# The Drax Power (Generating Stations) Order

Applicant's Responses to the Examining Authority's Second Written Questions

Drax Repower Project

Applicant: DRAX POWER LIMITED  
Date: January 2019  
Document Ref: 8.5.17  
PINS Ref: EN010091

**Figure 9. Capacity retirements and new investments in the High Renewables scenario**

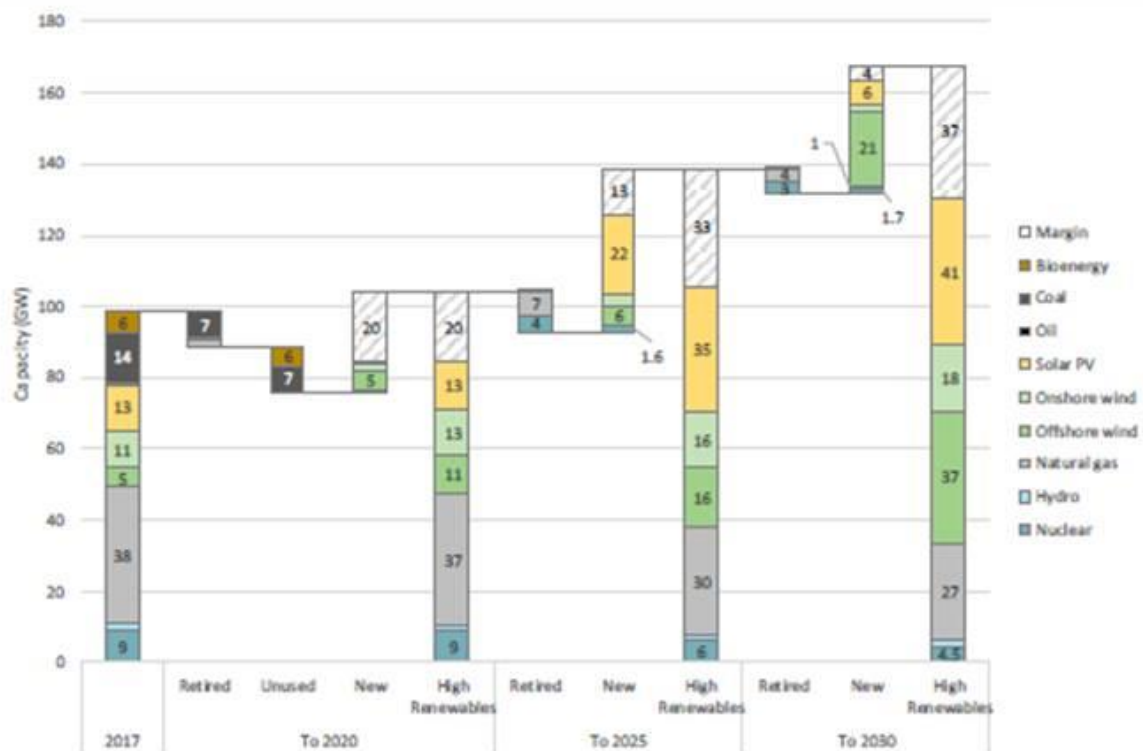
- 2.1.10 Figure 9 from Vivid Economics report, below, shows the growth in margin plant required to offset the expected closure of unabated coal power generation.
